Please refer to your letter of December 6 raising certain questions or requesting additional information in regard to our Revised Environmental Report of November 1971 and our Supplemental Environmental Report of June 1972.

ENVIRONMENTAL REPORT
SEQUOYAH FACILITY
KERR-McGEE CORPORATION

SUPPLEMENTAL #2

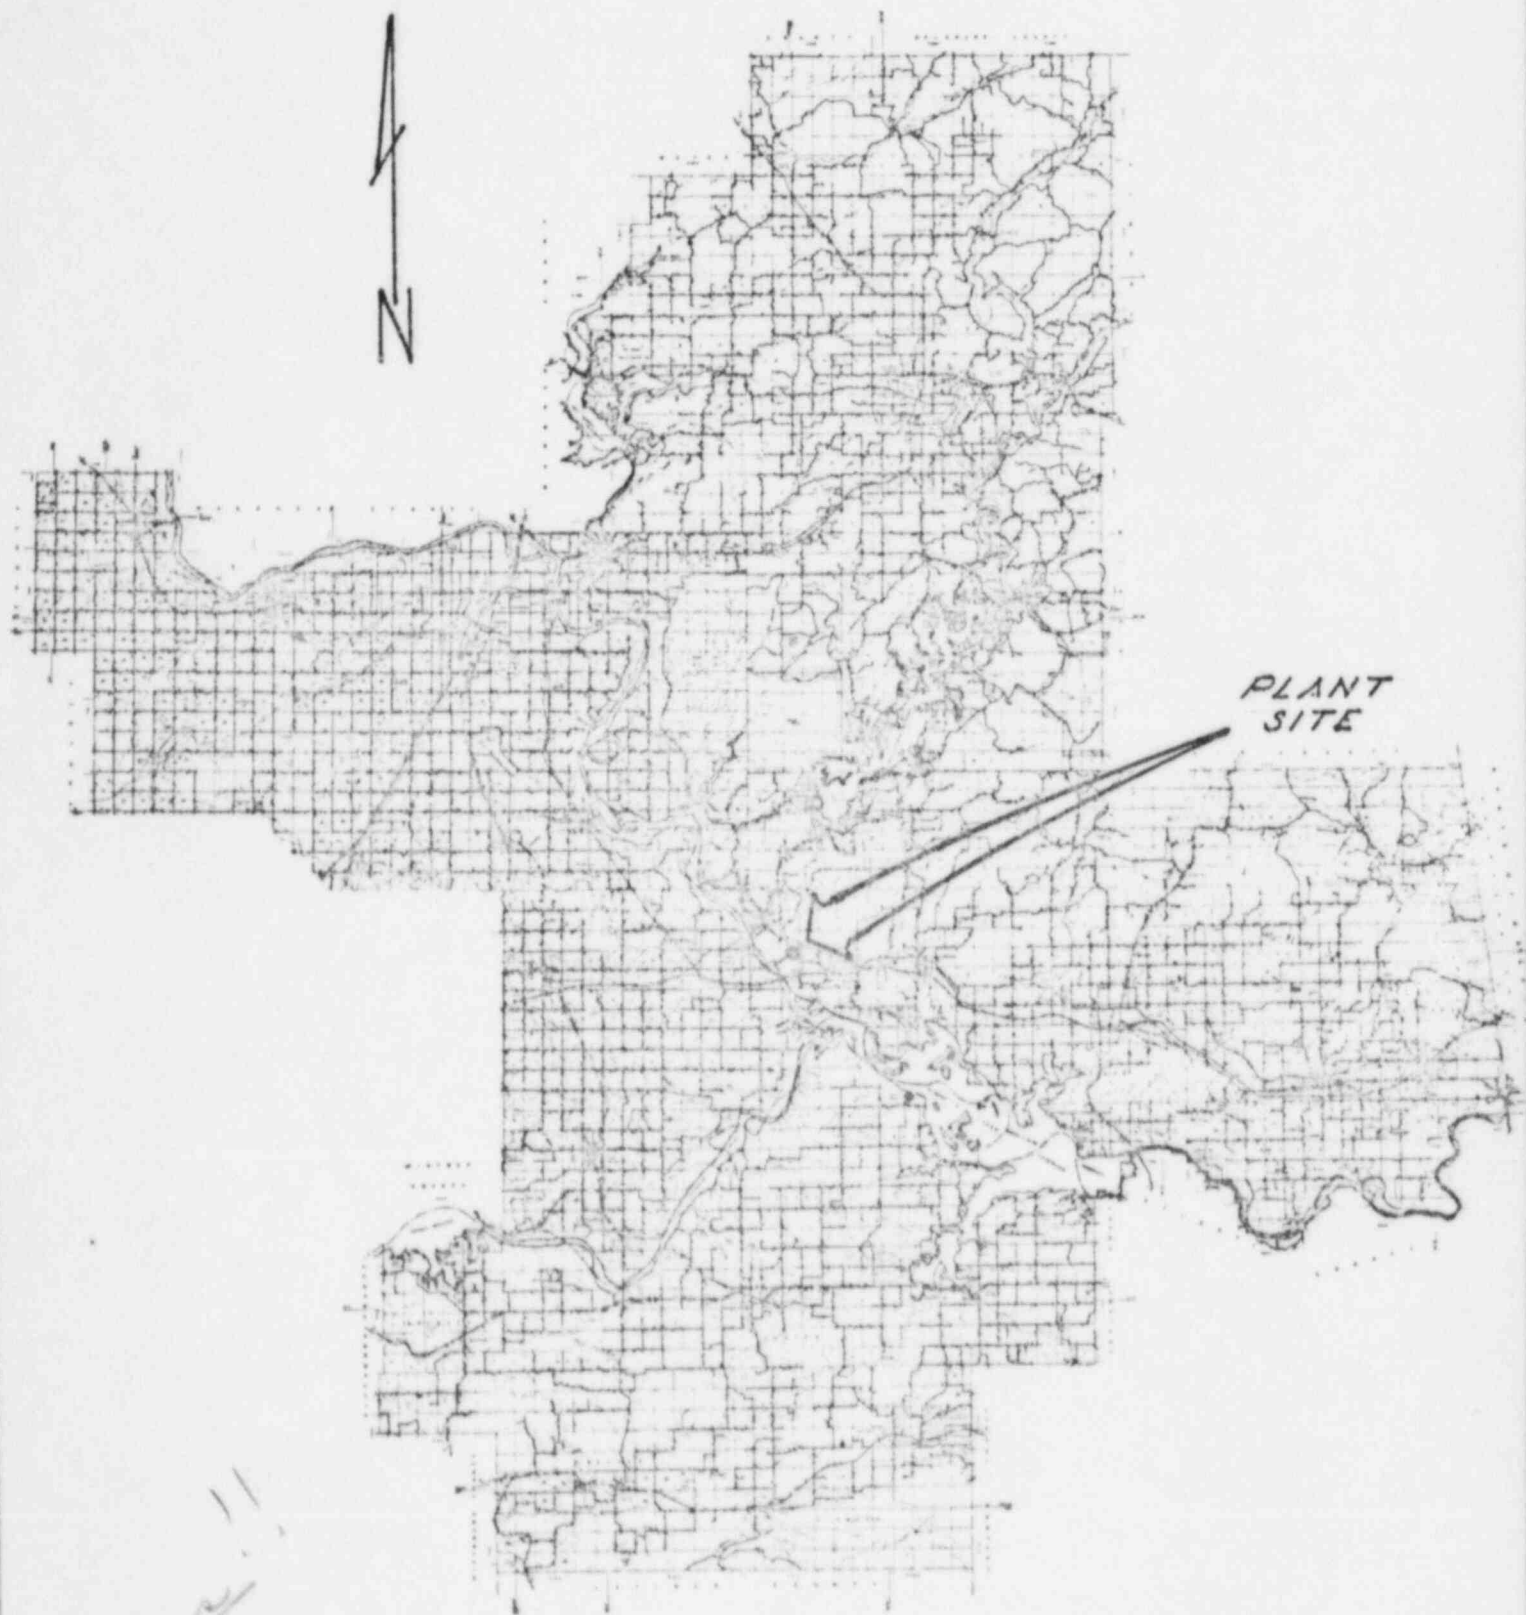
- (2) Maps provided (Figure 1 in particular) are not very clear. Suggest substituting following 8 x 10 1/2" drawings:

- OK ?
(a) General map of State of Oklahoma pointing out plant site (scale about 50 miles per inch),
(b) Second map showing general area details i.e., towns, roads, rivers, etc. (scale about 10 miles per inch)
(c) Third map similar to insert in present Figure 1. (scale about 4 miles per inch)
(d) Plant area map (scale about 1500 feet per inch) up-dated to show all existing ponds, monitoring points, residences, etc. alone with distances from air-borne effluent release point to possible critical exposure points; e.g., school, homes, roads.

The maps requested are enclosed. We feel, however, that this request, if such fixed criteria for such reports exists, should be included in the guidelines for such reports. Figure 1 is a reduction of Drawing 110-C-151 included with the Revised Environmental Report. The location of the houses and school are circled and the distances tabulated.
